CITY OF DOVER

PLANNING TECHNICAL REVIEW COMMITTEE –AGENDA

TECHNICAL REVIEW COMMITTEE MINUTES – P19-07

Below please find our responses to the January 31, 2018 Technical Review Committee Minutes as to how our plans have been revised to address these comments.

UTILITIES PLAN

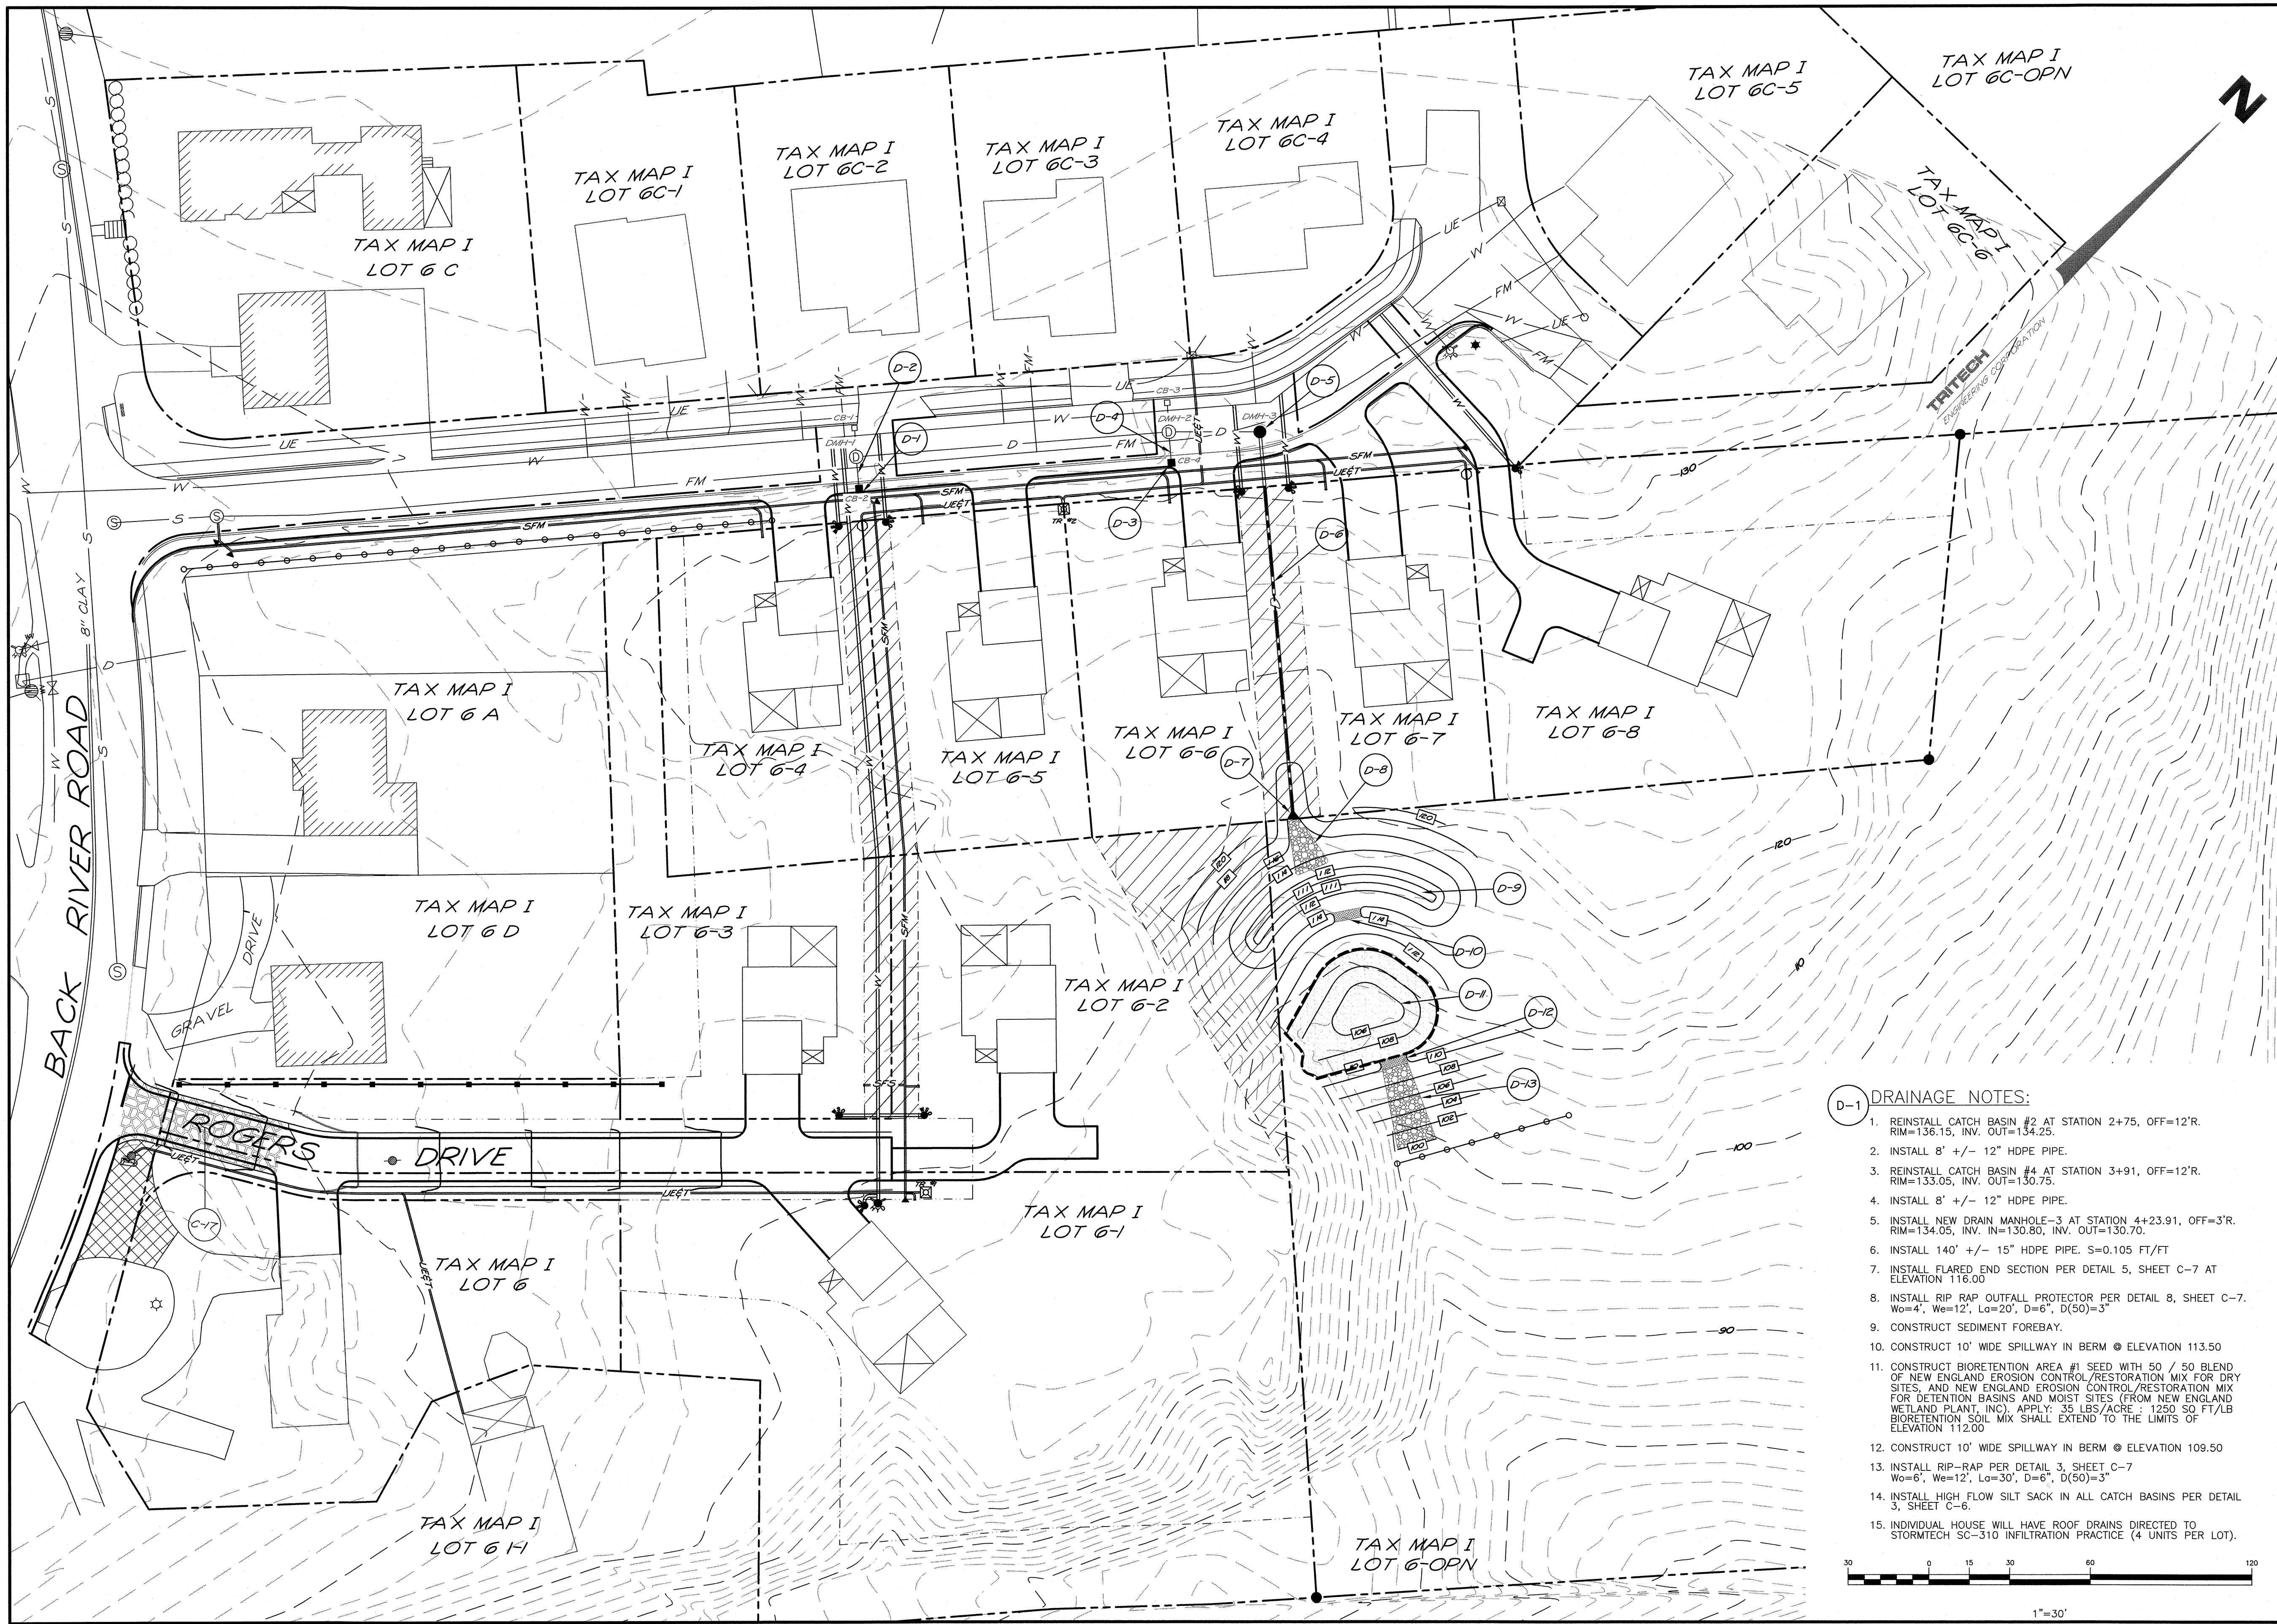
- Plan SP-2 discuss regular hydrant vs blow off hydrant.
-The existing hydrant shown on Back River Road is only 150 feet from the hydrant; therefore, the yard hydrant is adequate.

5 PRIVATE DRIVE SECTION
NOT TO SCALE

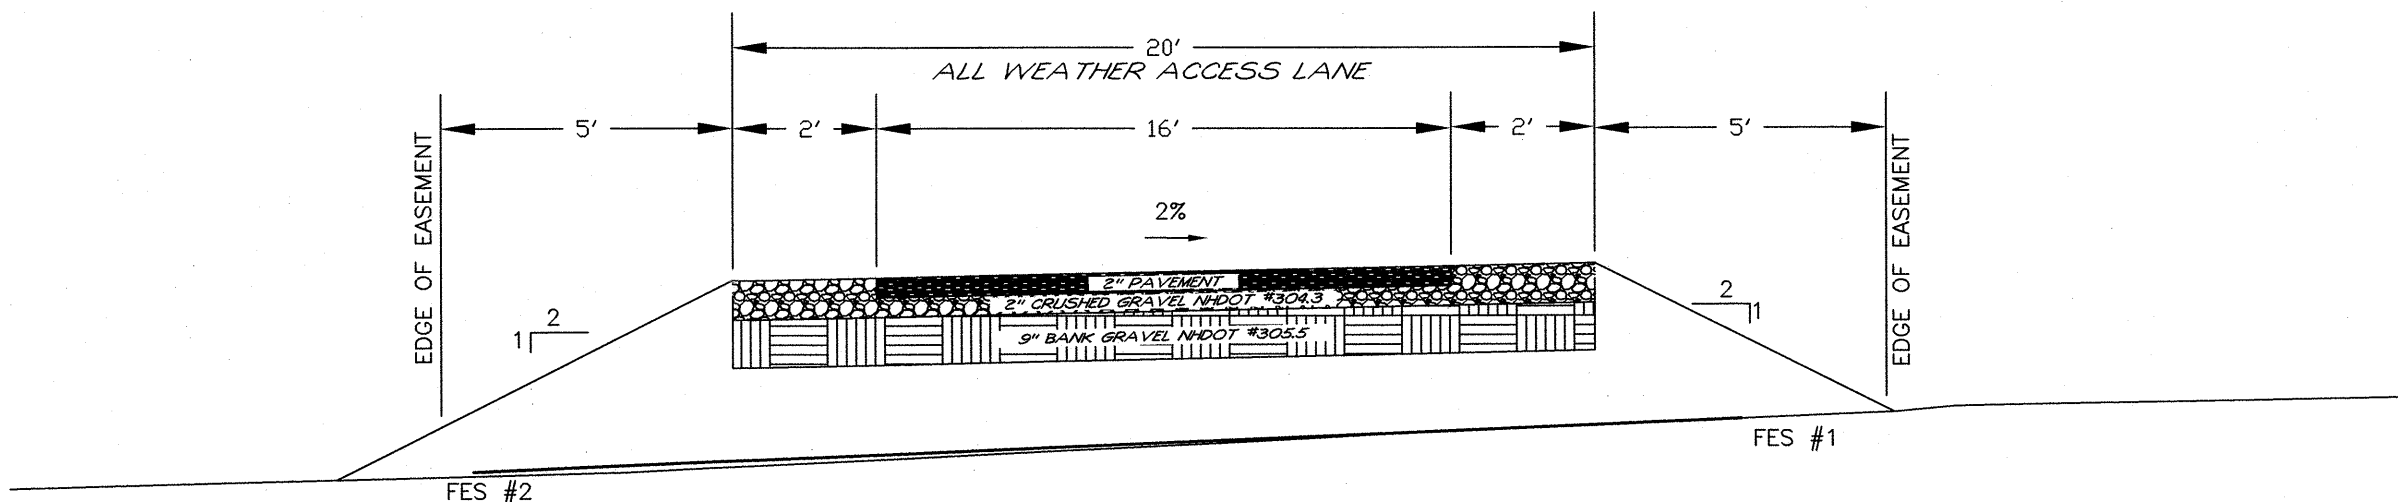
- Provide a road name for the private drive
-The common drive will be named "Rogers Drive".
- Provide a note on plans indicated site shall maintain year around access in all weather conditions.
-Detail 5, Sheet C-6 shows 20 feet of all-weather access.

- Plan S-1 note 19 indicates the site is for SFD however application appears to be for 6 sfd and 2 duplexes.
-Note 19 on Sheet S-1 is accurate.
- Clarify the width of the structural roadway
-Detail 5, Sheet C-6 shows 20 feet of all-weather access.
